Re: Rapiscan AIT System Radiation Survey Reporting

Rapiscan 2010	Secure 1000 Radiation Emission Measurement	FORM R-0646-1 (Single Pose)
-------------------------	---	------------------------------------

R-0646-1 Addendum (Documentation Errors)

Product Name	Secure 1000SP (Single Pose)
Serial Number	S51037008
Radiation Emission Measurement	Radiation Survey Dated: 10/19/2010
RSO Initials

1. In Beam Dose Measurement: Survey Table. 1

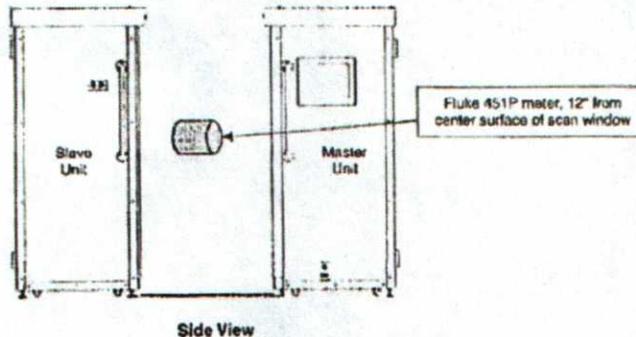
1. Incorrect values for operating parameters. Values should have read: 50kVp and 5mA.
2. Technician did not indicate scan time. Correct scan time is 3 seconds.

The service technician should attend refresher training.

The corrected data indicates this system was operating within expected parameters. No re-survey is required for this system.
